Docket No. 50-423
F0592A
F0592B

Millstone Nuclear Power Station, Unit No. 3
Probabilistic Safety Study (PSS)

Request for Additional Information
Millstone Nuclear Power Station, Unit 3
Docket No.: 50-423

FIGURE 2.4-36
 HATCH COVER DETAILS -
 CIRCULATING WATER PUMPHOUSE
 SERVICE WATER PUMP CUBICLE
 MILLSTONE NUCLEAR POWER STATION
 UNIT 3
 FINAL SAFETY ANALYSIS REPORT

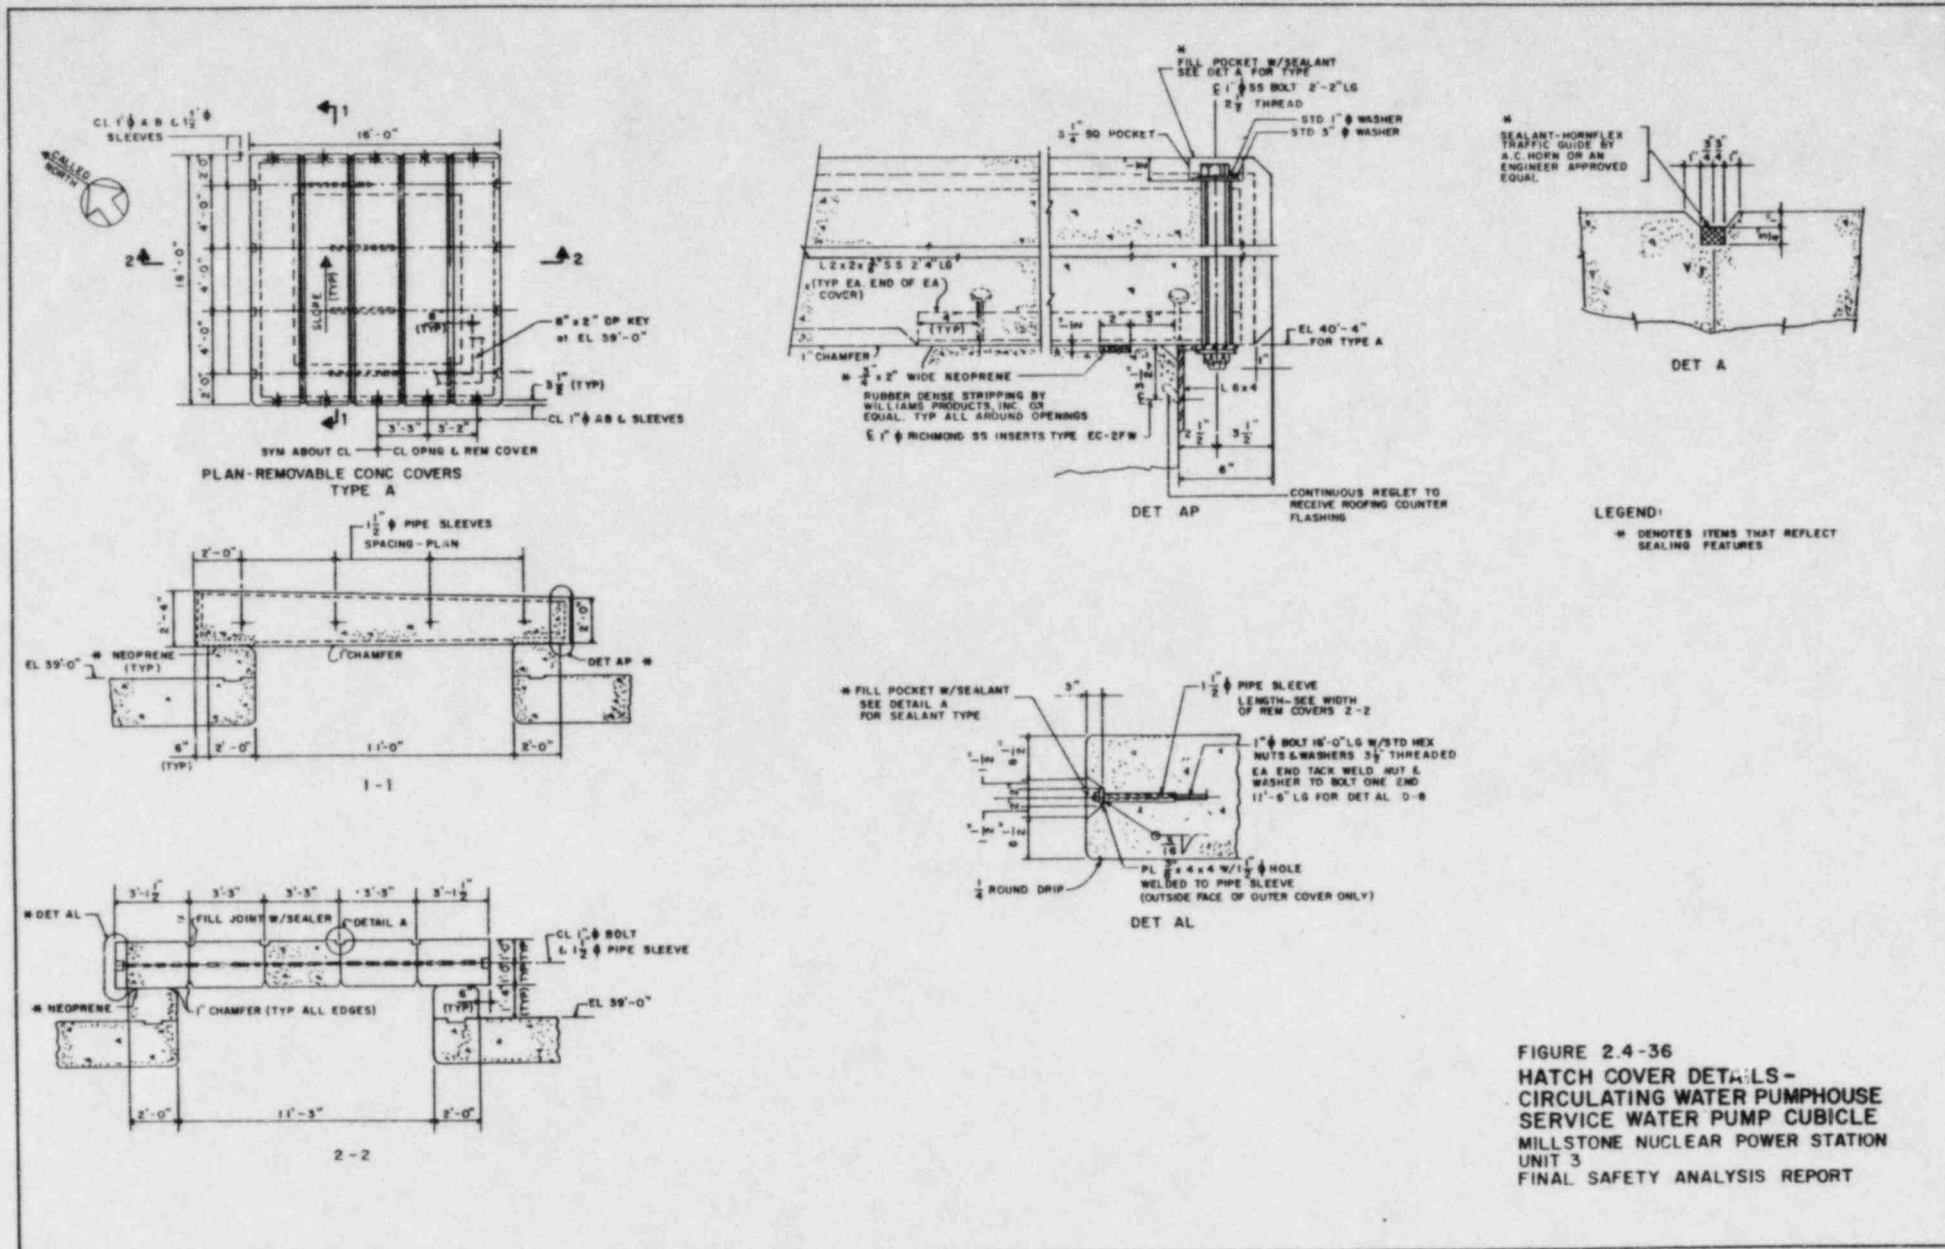
Question 720.92

The intake structure has hatches over the service water pumps. Each service water pump room has two service water pumps. We believe that failure of the two pumps in a pump room due to roof leakage is completely coupled.

- (a) What is the probability that the service water pump hatch seals leak during a severe storm and disable the pumps?
- (b) Estimate the common cause failure probability for loss of service water pumps in both rooms due to roof leakage.

- (a) Attached is Figure 2.4-36 from the FSAR depicting the hatch covers over the service water pumps. The covers consist of pre-cast concrete sections which weigh approximately 76,800 lbs. and rest on neoprene gaskets to produce a very effective sealing mechanism.

A highly conservative design bases type analysis was performed using Hydrometeorological Report No. 51 (HMR 51) and No. 52 (HMR 52) to determine the water surface elevation on the intake structure roof during a postulated PMP event. Based on the PMP guidance for rainfall depth-durations contained in HMR 52, a rainfall intensity of 70.4 in/hr for a five minute duration was used to perform this analysis. The results, which are tabulated in Table 2.4-12 of the FSAR, show that during this five minute event the water surface would exceed the elevation of the hatch seals by approximately 0.5 in.

The impact on the S.W. pumps of this 0.5 in. of water against the hatch cover for the five minute duration was evaluated as follows. As shown in Figure 2.4-36 the neoprene seals consists of continuous strips of dense neoprene, 2-in. wide by 3/4 in. thick, set in a 2 in. x 1/2 in. groove in the concrete. The probability of failure for this neoprene seal arrangement was assessed to be negligible, and any localized failure would not result in an infiltration of water which would endanger the service water pump cubicles. A postulated condition of no neoprene seal was considered to ascertain the impact on in-leakage. Due to the low head, 0.5 inches, and the resistance to flow that would be encountered along the concrete/concrete interface, in-leakage would be minimal using these conservative assumptions. Therefore, based upon a highly conservative analysis (the evaluation using the PMP event) the probability of in-leakage through the hatch seals is extremely small and need not be considered.

- (b) There are four separate hatches (2 ft. thick reinforced concrete slabs) on the roof of the building to allow major repairs to each of the four service water pumps. Two service water pumps are located in each of the two separate pump train cubicles. The joints between the slabs are sealed with an auto traffic grade sealer. With only routine maintenance of the structure roof, leakage of any type should not occur. In the highly unlikely event that one of the hatches developed a catastrophic type leak concurrent with a highly unlikely excessive rainfall event and drained water into one of the compartments the maximum credible effect would be

FIGURE 2.4-6
 FREQUENCY OF TIDAL FLOODING
 AT NEW LONDON, CONNECTICUT
 MILLSTONE NUCLEAR POWER STATION
 UNIT 3
 FINAL SAFETY ANALYSIS REPORT

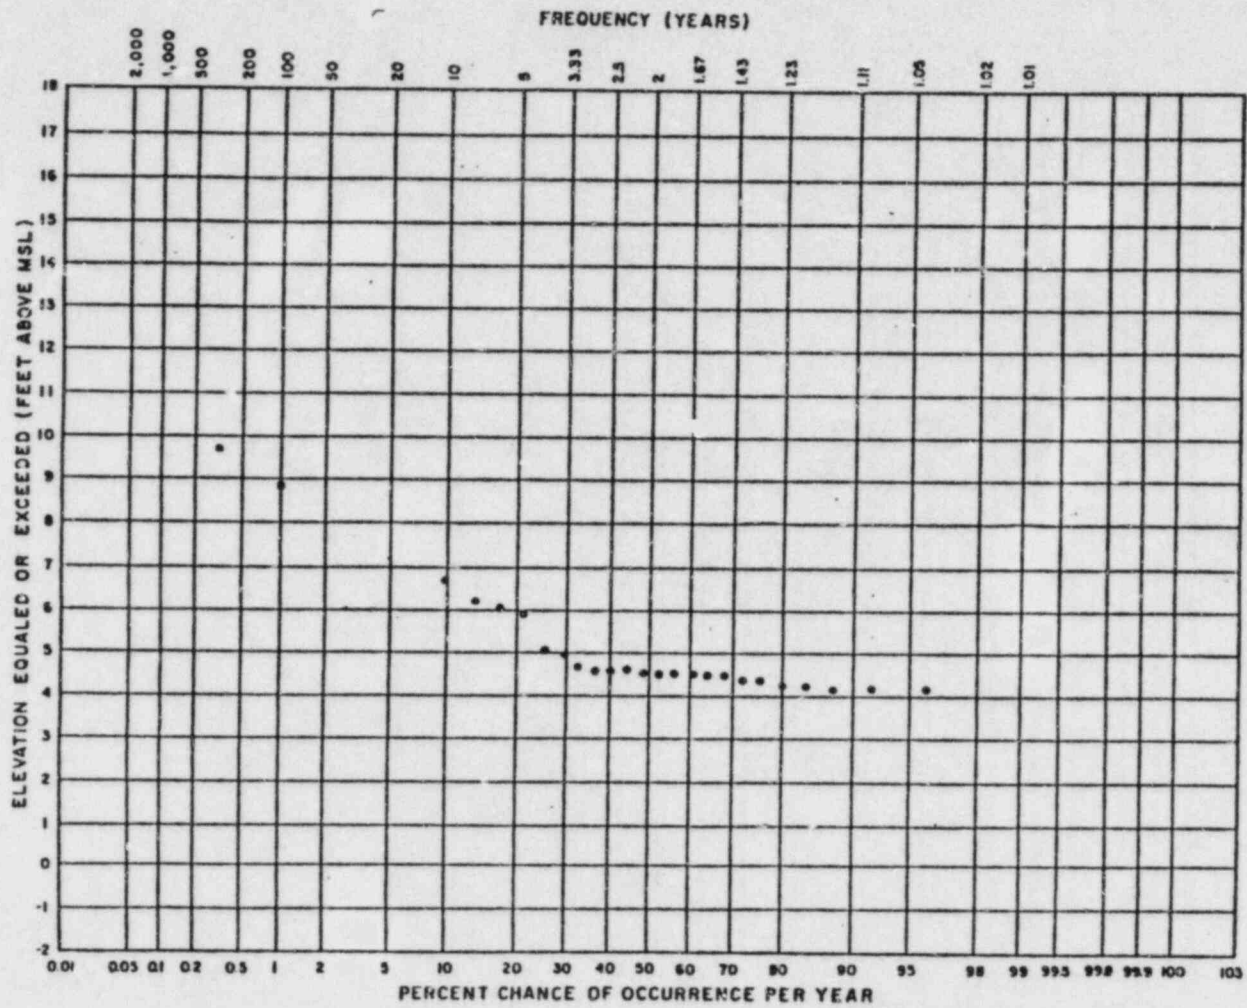
Storms of lesser severity than the PMH can have wave run-up which exceeds the height of the door threshold for the service water (SW) pump rooms inside the pumphouse. We understand that due to the design of the circulating water system, water will rise inside of the circulating water pump bays as the water level increases outside.

- (a) Estimate the annual frequency that the water level, due to wave action from a storm including run-up, is above the door threshold of the intake structure SW pump rooms.
- (b) Estimate the probability that these doors (which provide entry into the SW pump room) will not function as water-tight barriers due for example to door seal leakage or improper door closure.

- (a) The elevation of the threshold to the water-tight doors is 14.75 feet. Attached is Figure 2.4-6 from the FSAR entitled "Frequency of Tidal Flooding at New London, Connecticut." This figure is based upon historical data in the vicinity of Millstone and includes the occurrence of the 1938 Hurricane. Extrapolation of this data indicates that the recurrence interval for tidal flooding above elevation 14.75 is greater than 2000 years. This would equate to best estimate frequency of occurrence of $5 \times 10^{-4}/\text{yr}$.
